Final Environmental Impact Statement

Proposed Four-Lot Subdivision

Incorporated Village of East Hills, New York

FINAL ENVIRONMENTAL IMPACT STATEMENT

PRELIMINARY MAP OF MELBY COURT LANDSCAPE AND TREE REMOVAL PLAN

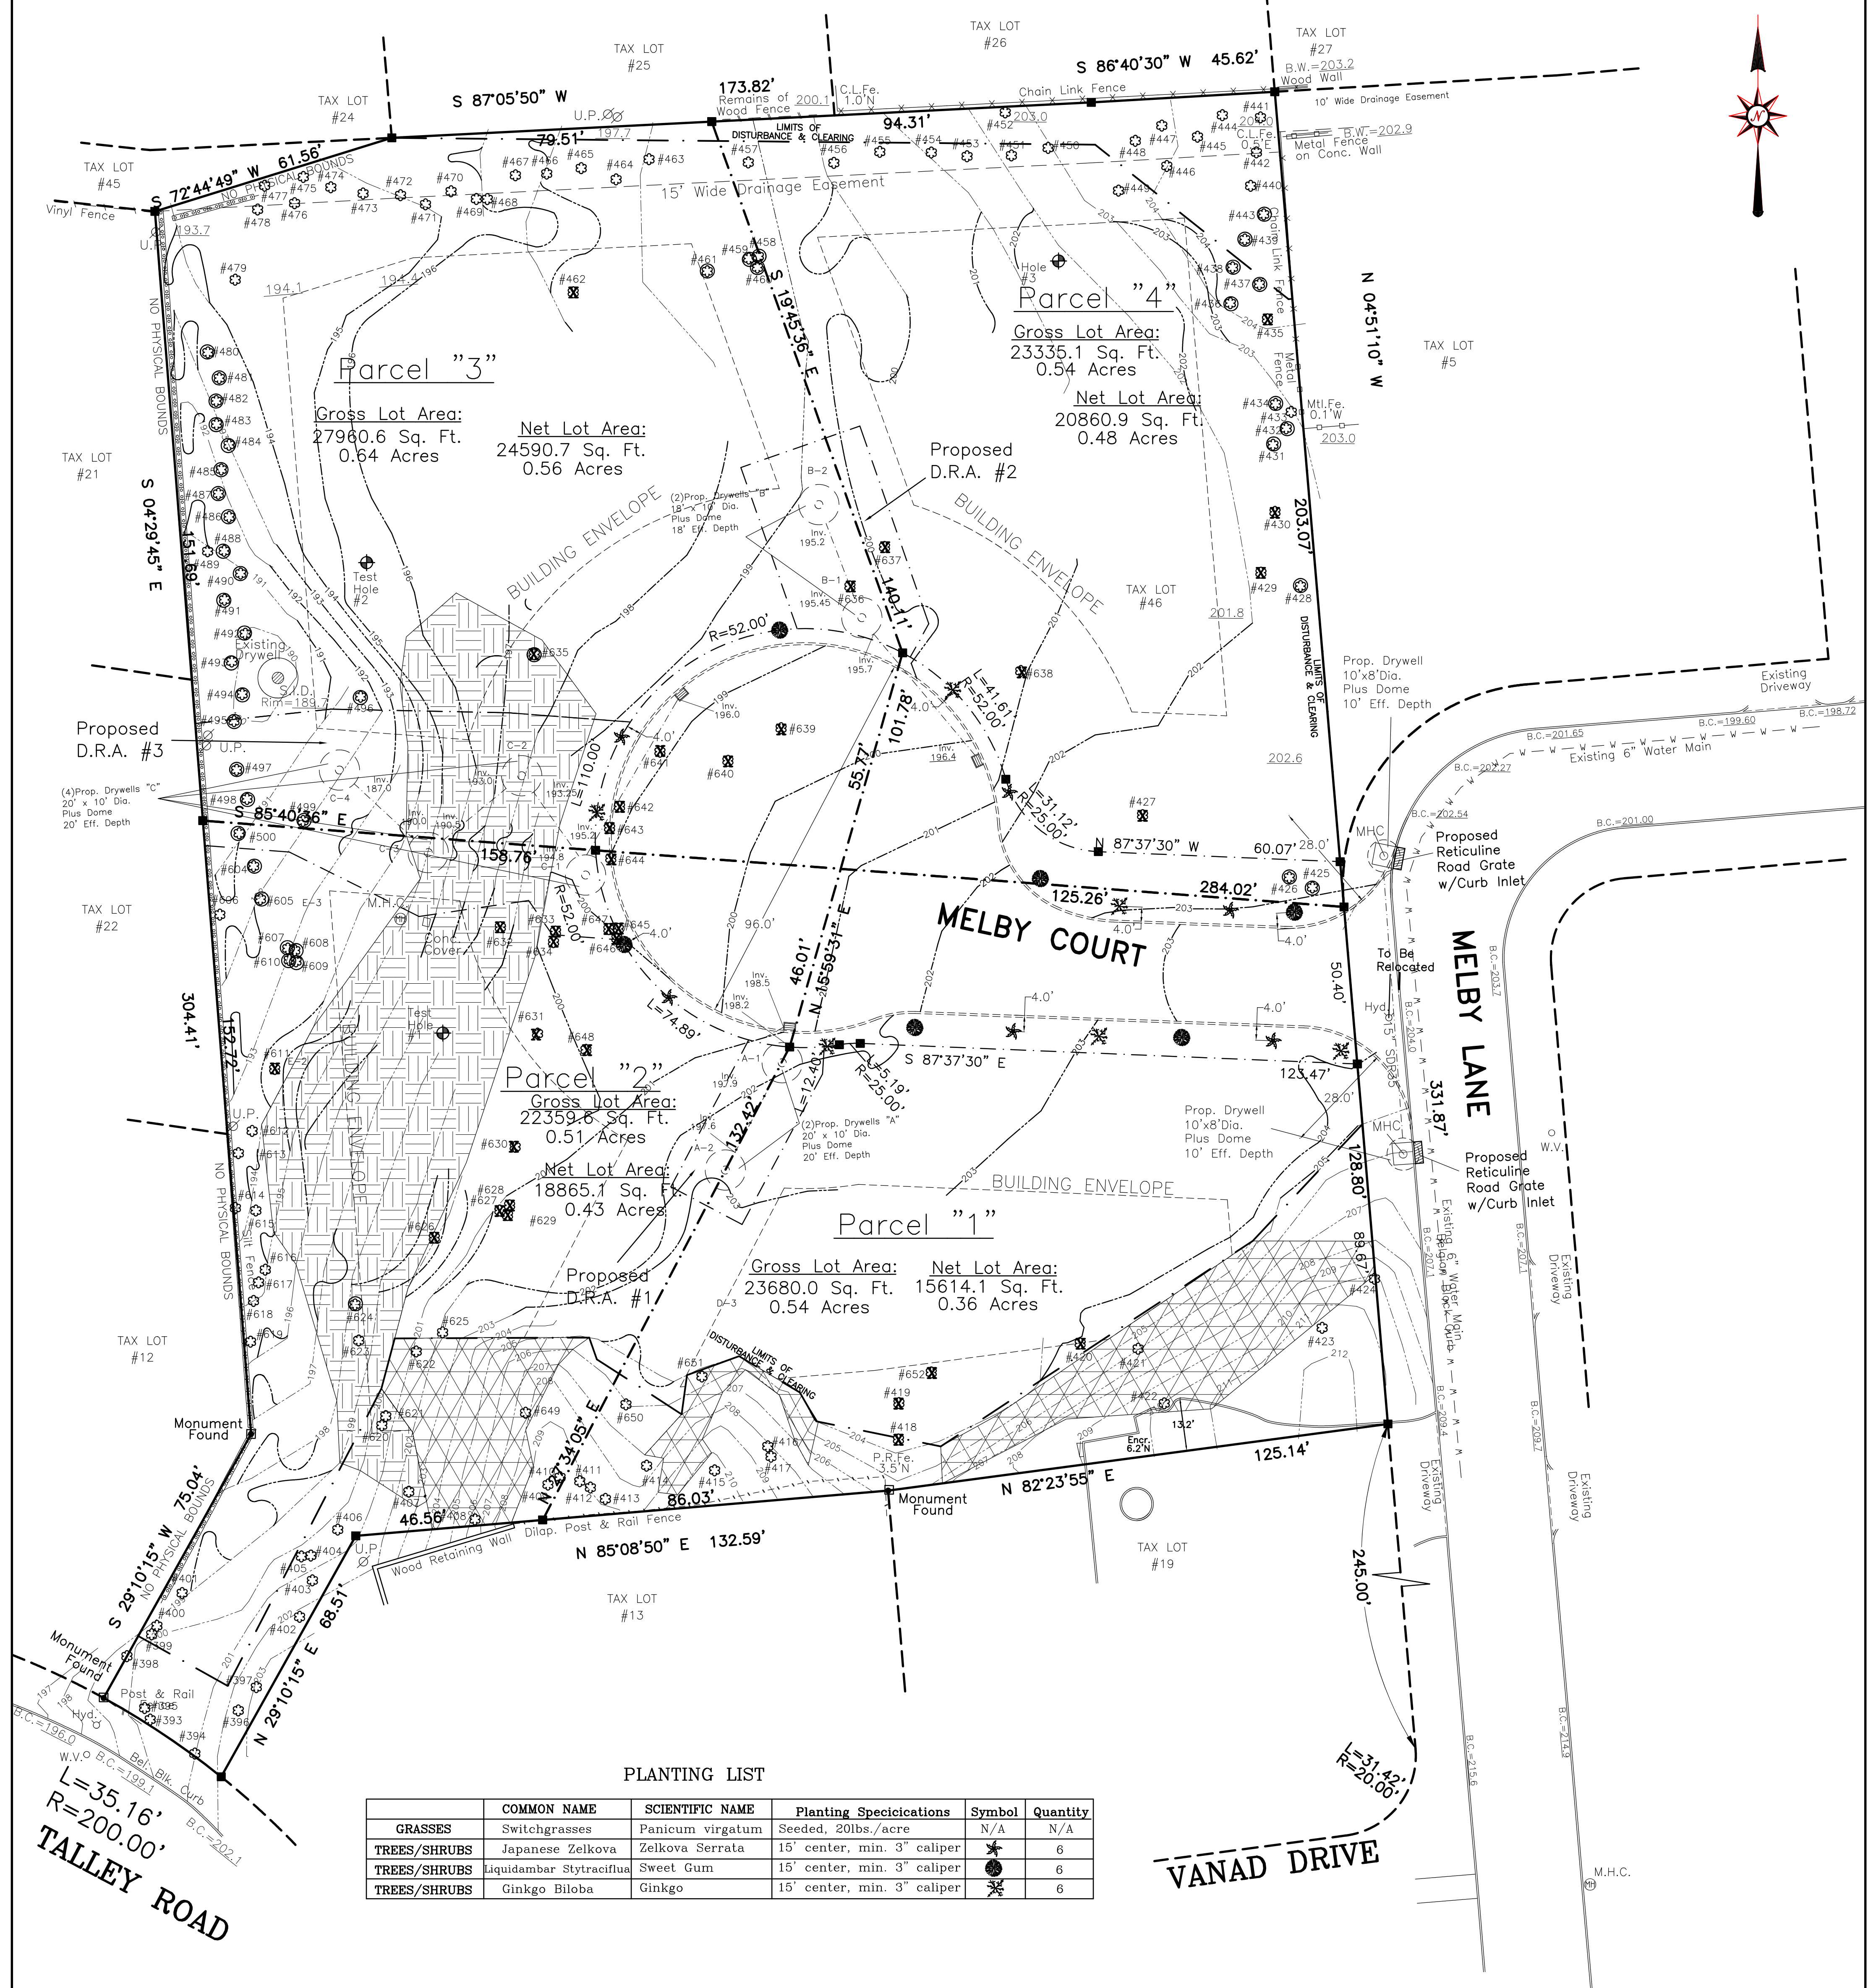
The Landscape and Tree Removal Plan Sheet 5 of 7 should be reviewed with respect to proposed grading and disturbance within close proximity to existing trees shown to remain. A number of trees to remain are shown within the limits of disturbance and immediately adjacent to or within proposed grading areas. Methods to retain/protect such trees described, and the mechanism that would be implemented to ensure the preservation of the identified trees on private residential lots in perpetuity should be discussed.

Label street tree species on plan using a symbol. See redline comments on Sheet 5 of 7.

The limits of clearing are the same as the limits of disturbance. All labels on each sheet have been revised to show "Limits of Disturbance & Clearing." Any trees within the disturbance area to be preserved are shown to have tree protection installed for the construction process. Tree protection for existing trees within the disturbance areas is detailed on Sheet 6 of 7, *Landscape and Tree Removal Plan*. A tree protection fence will be installed around all trees to remain to prevent any damage to the trees. Sheet 6 shows all trees to be protected within circles to indicate the tree protection fence. Installation of the protection fence is shown in detail. The *Grading and Drainage Plan* (Sheet 7 of 8 in Appendix E of this FEIS) does not show any

Symbols have been added to Sheet 6 of 8 for all species of trees (see Appendix E of this FEIS).
